ITEM FOR ENVIRONMENTAL BOARD AGENDA

NAME AND NUMBER OF PROJECT: 2203 Manana Boat Dock
SP-2007-0633D

MEMORANDUM

SUBJECT: 2203 Manana Boat Dock/SP-2007-0633D

2203 MANANA STREET SITE PLAN & BOAT DOCK PLAN	AUPPERLE COMPANY Engineering, Planning & Development Services 10088 Circleview Drive Austin, Texas 78733 512 422-7838		NO.	DATE	REVISION	APPROVED

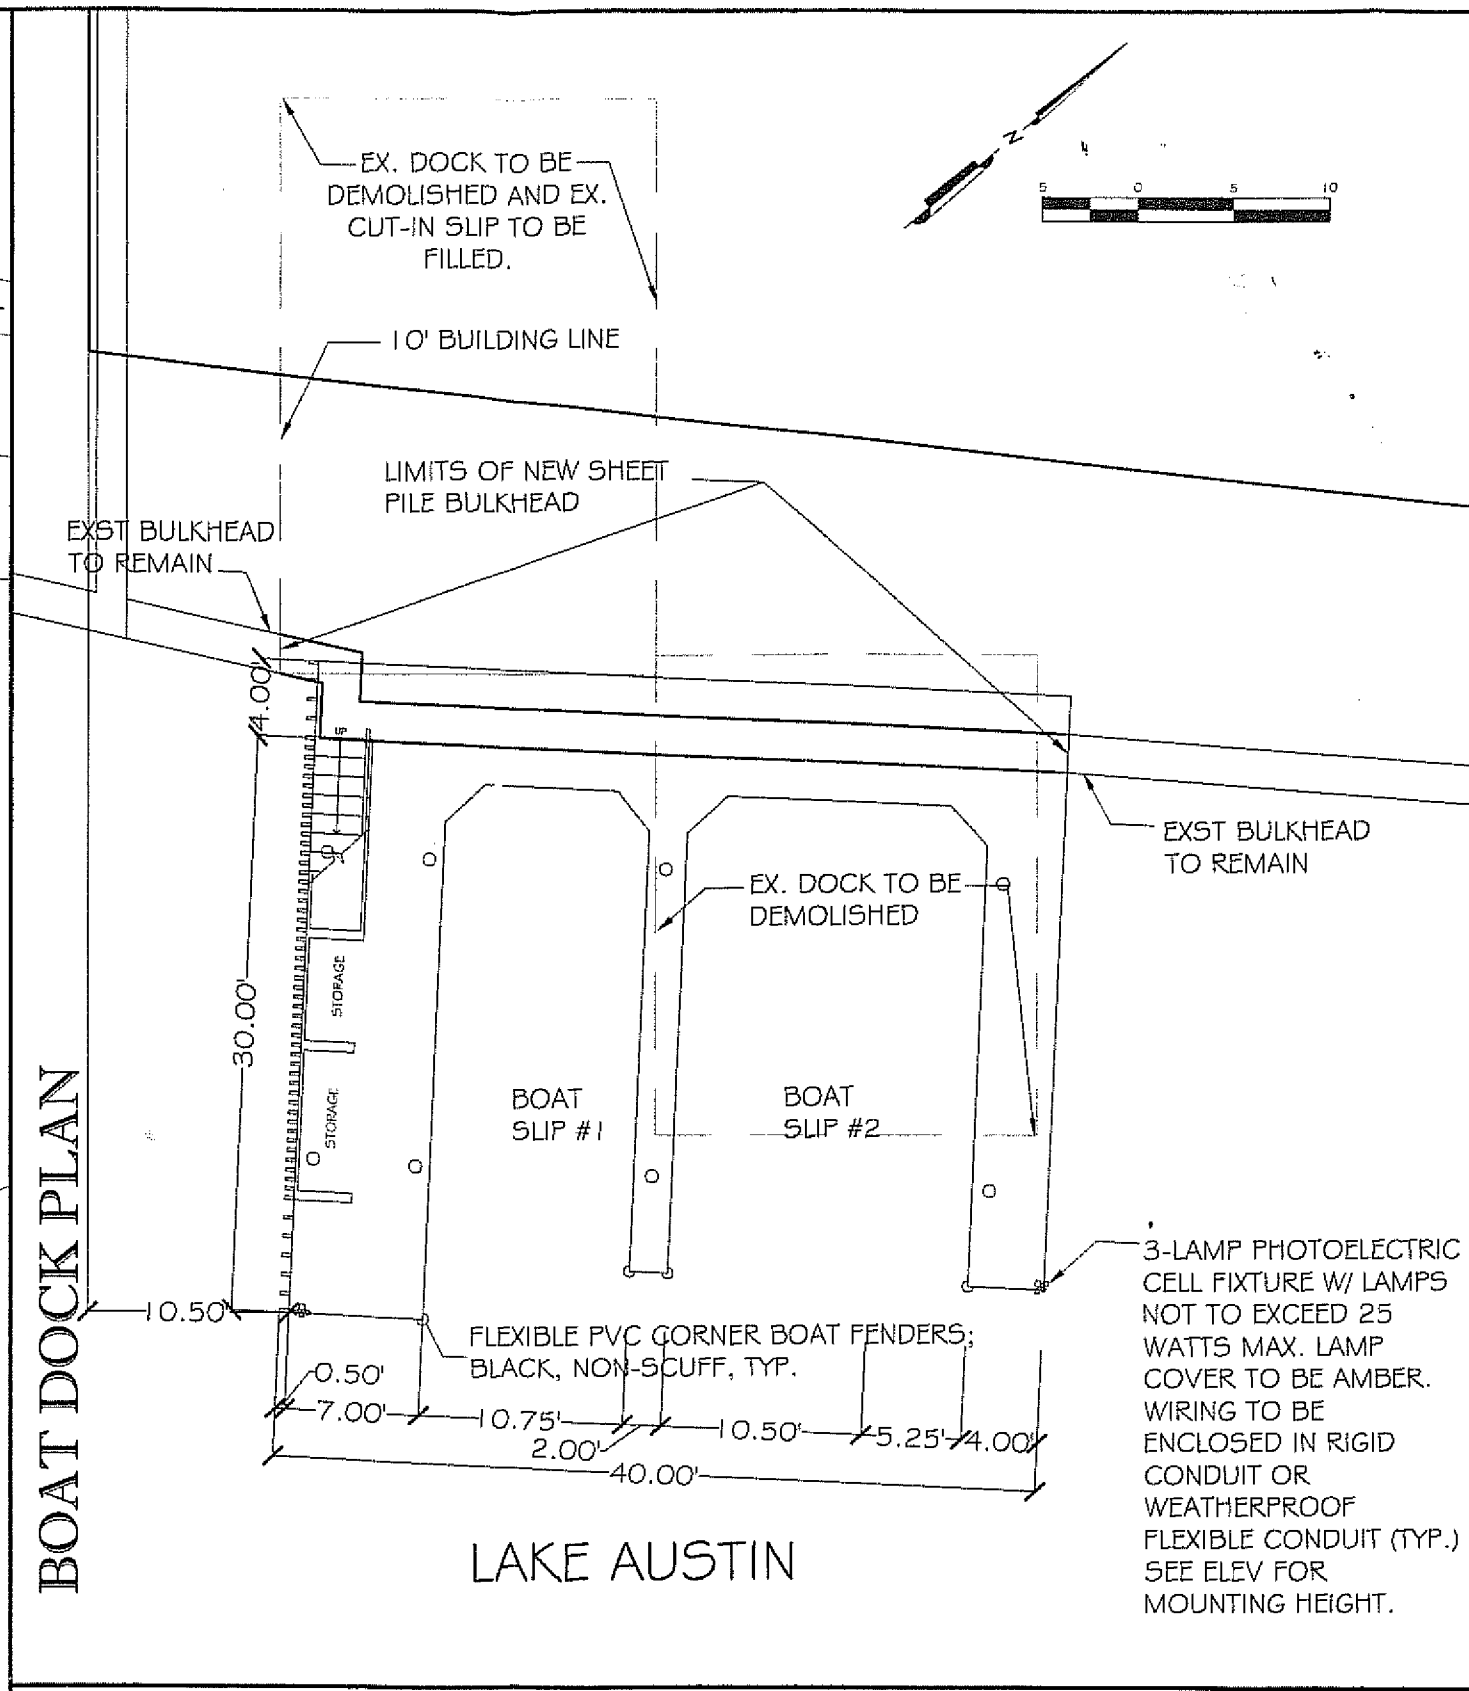
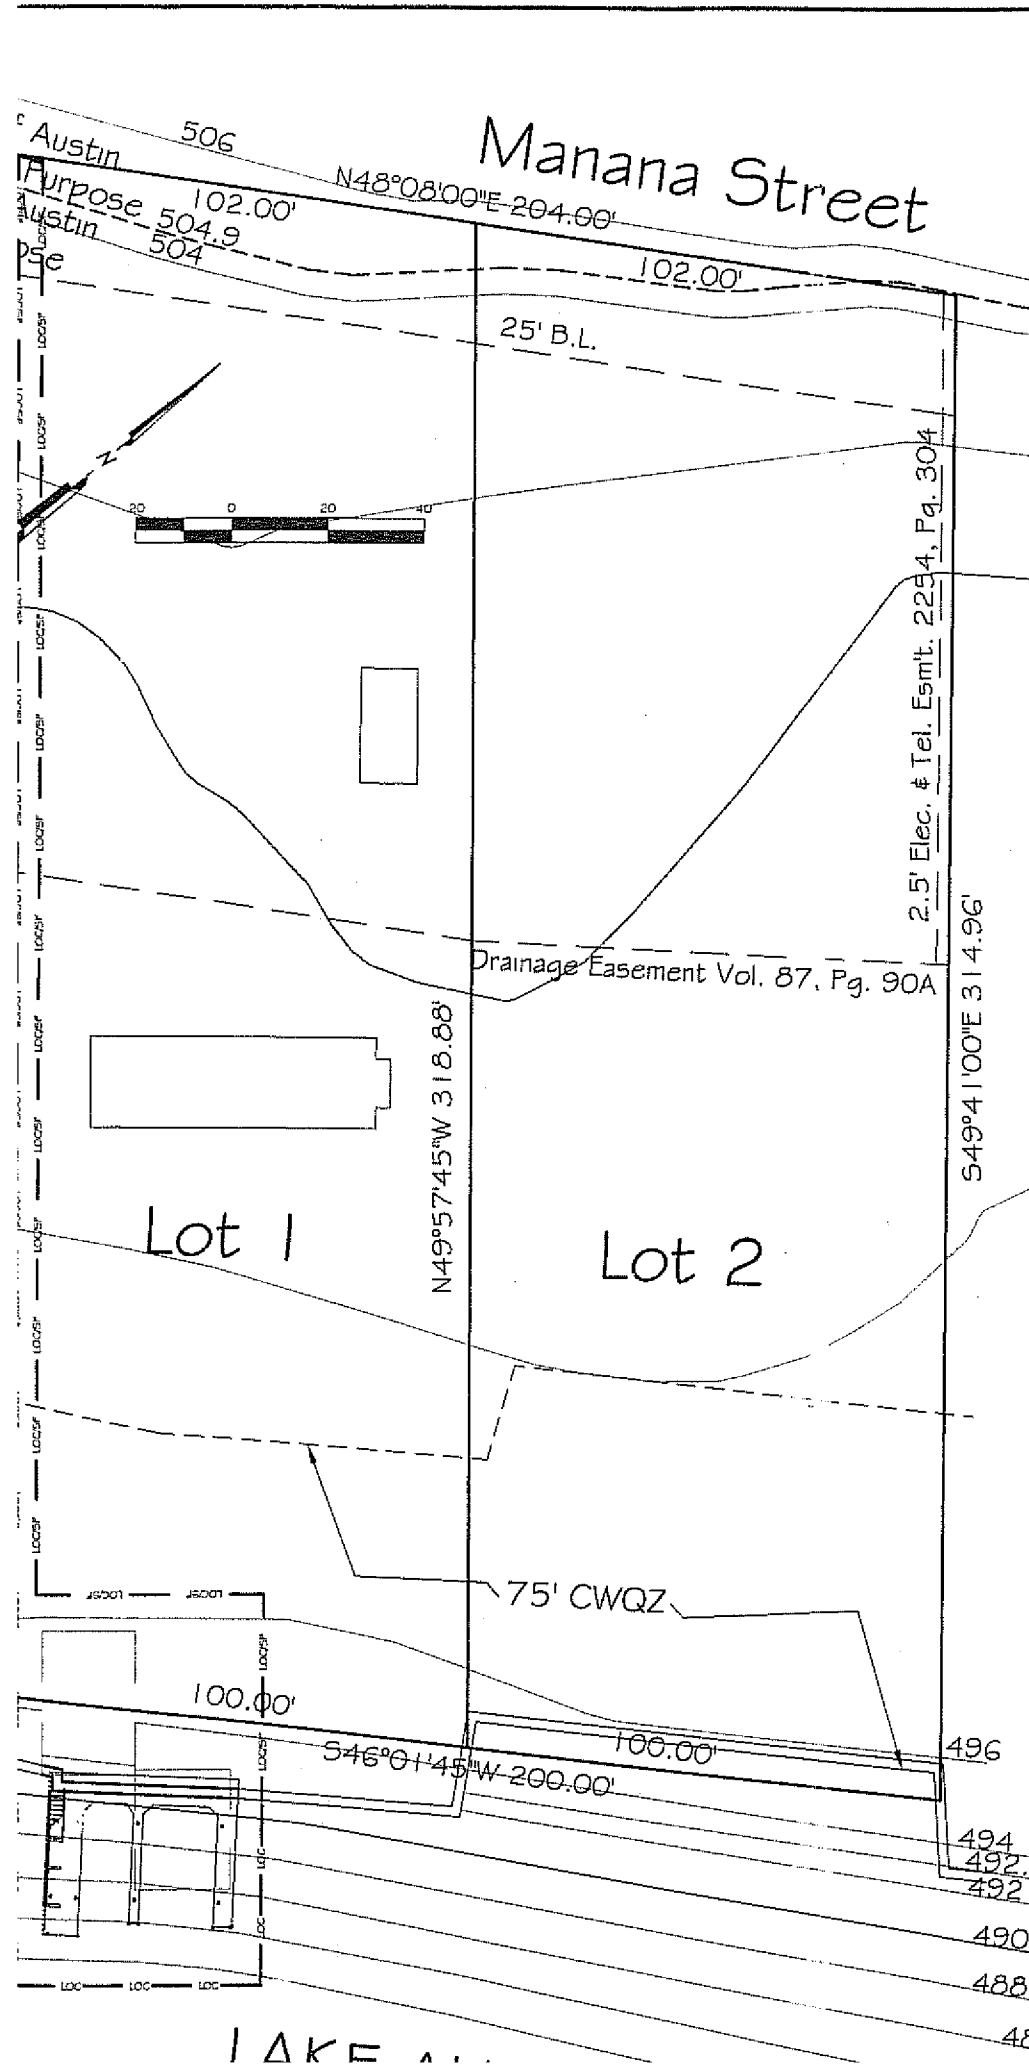
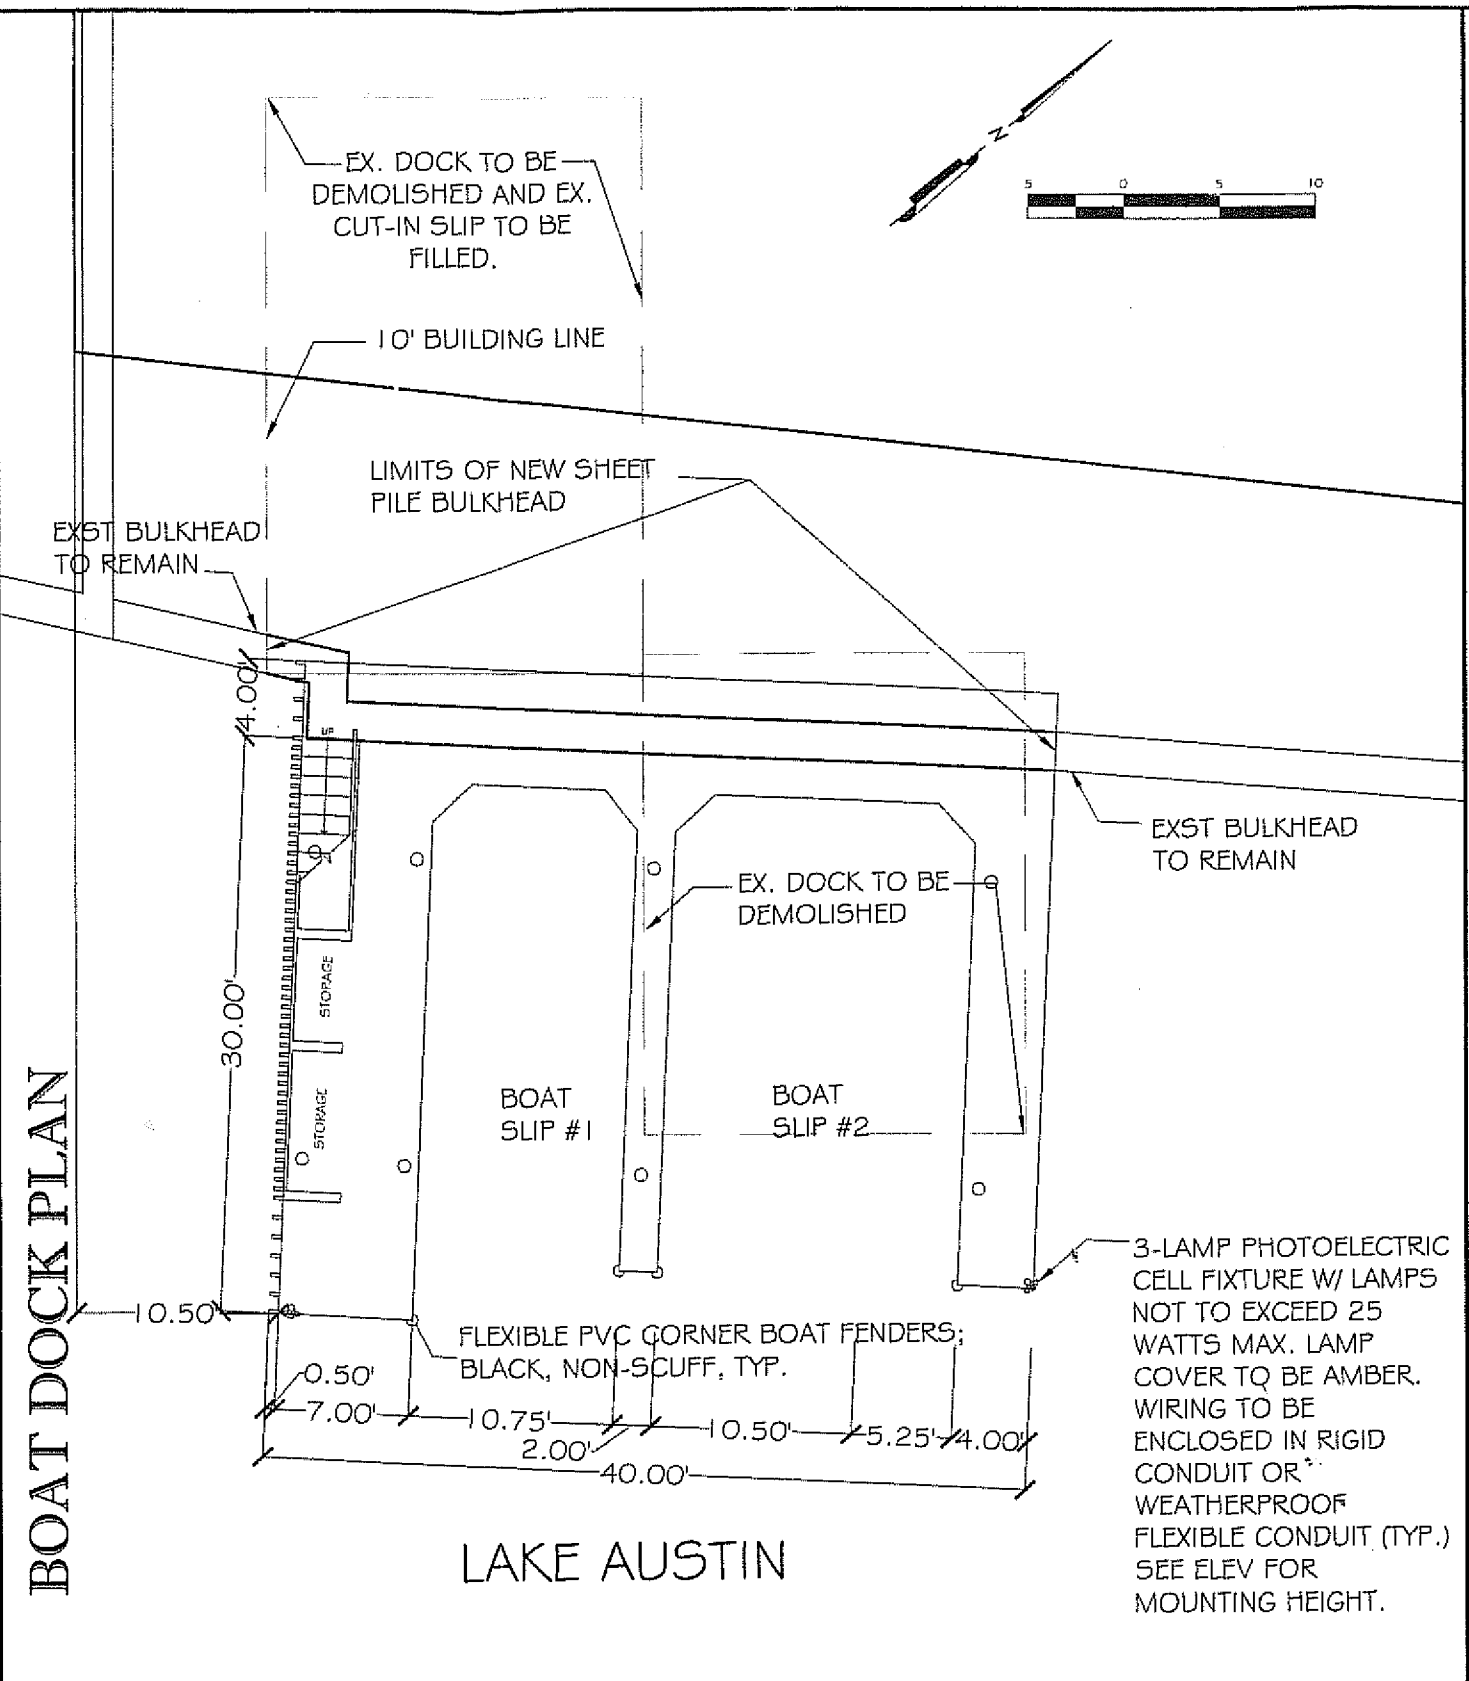
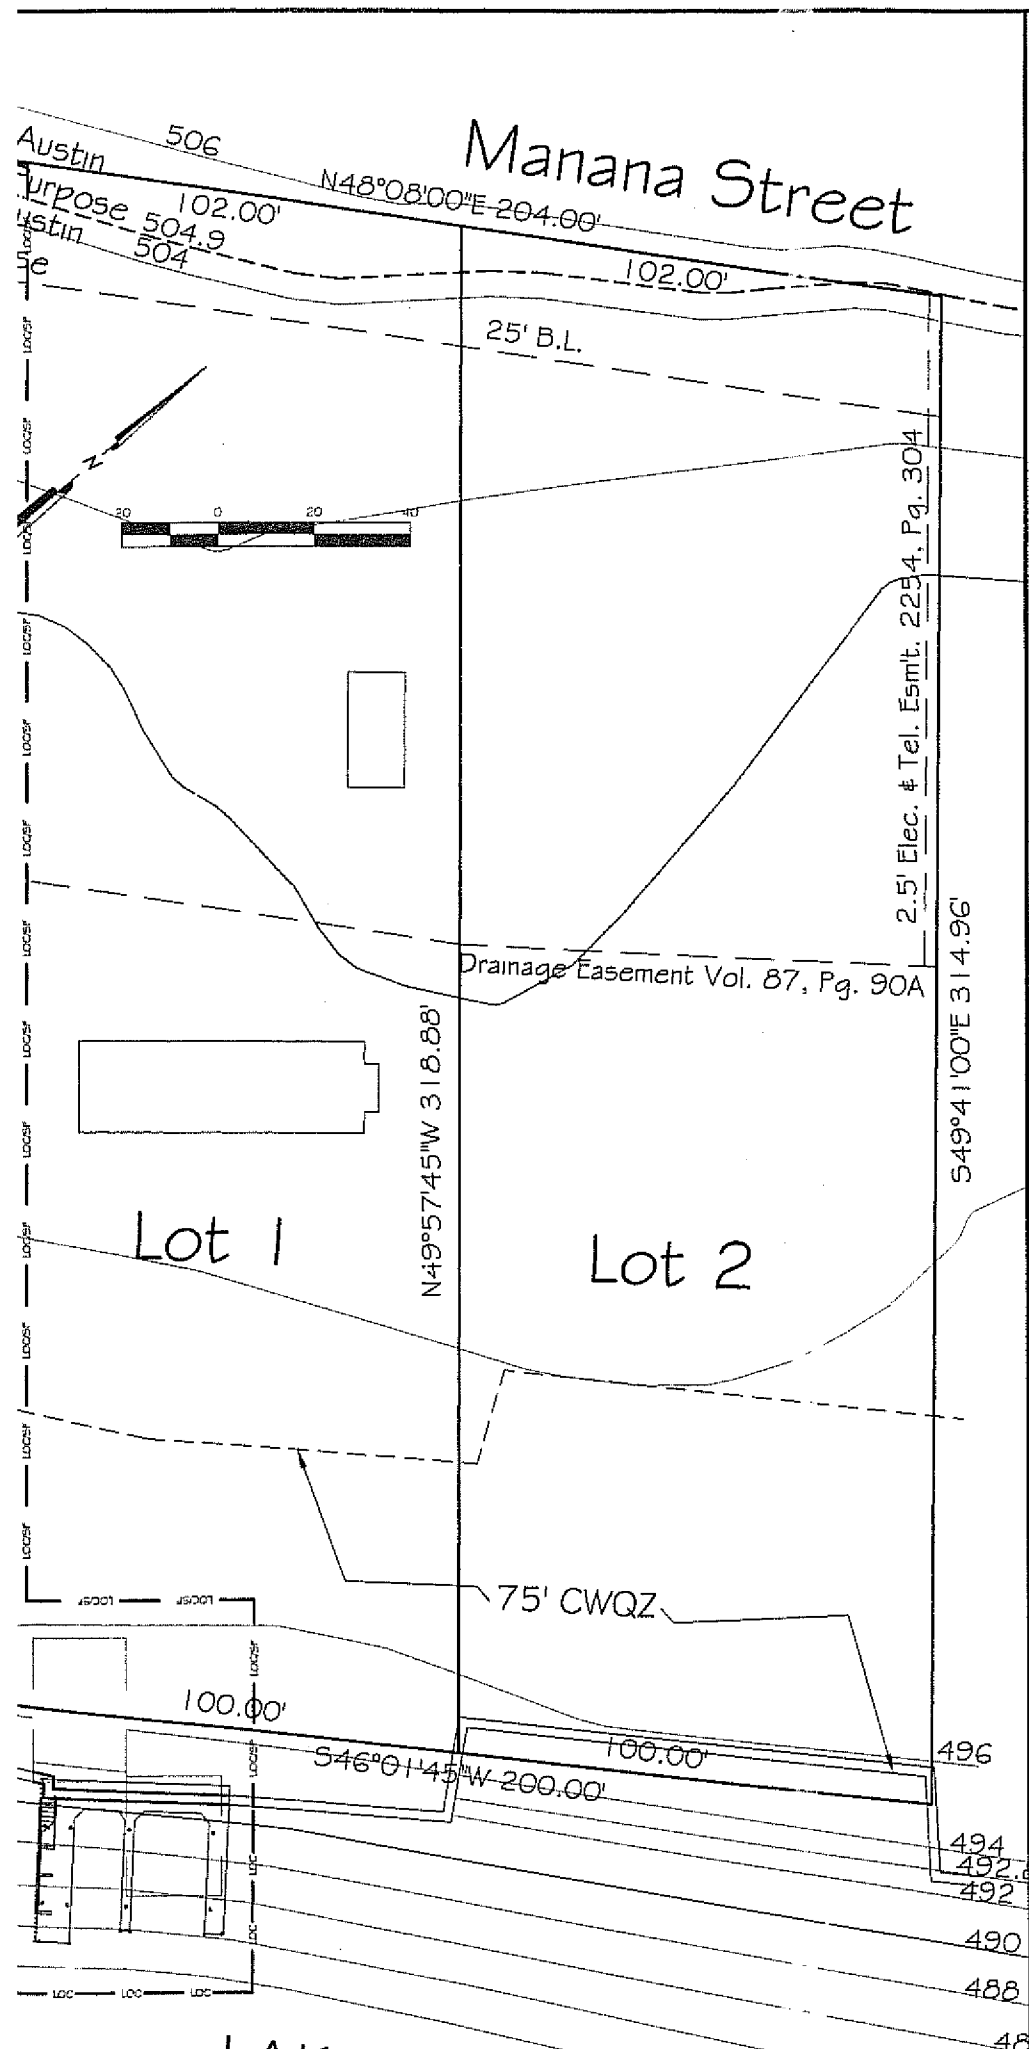
REQUESTS: Variance requests to fill in an existing man-made boat slip:
LDC Section 25-8-261 (Critical Water Quality Zone Development)
and 25-8-452 (Critical Water Quality Zone)

The applicant is proposing to fill an existing manmade boat slip and construct new boat slips in the Critical Water Quality Zone. The project will require variances from Sections 25-8-261 (Critical Water Quality Zone Development),

25-8-452 (Critical Water Quality Zone; Water Supply Rural Watershed) and 25-8-341 (Cut Requirements). Section 25-8-452 states that no development is allowed within a Critical Water Quality Zone of a Water Supply Rural Watershed unless it is allowed under Section 25-8-261. This type of development is not allowed under 25-8-261, so it is necessary to ask for a variance from both code sections.

Staff recommends the variances for the demolition of the existing boat slip and construction of the new boat slips because the findings of fact have been met.
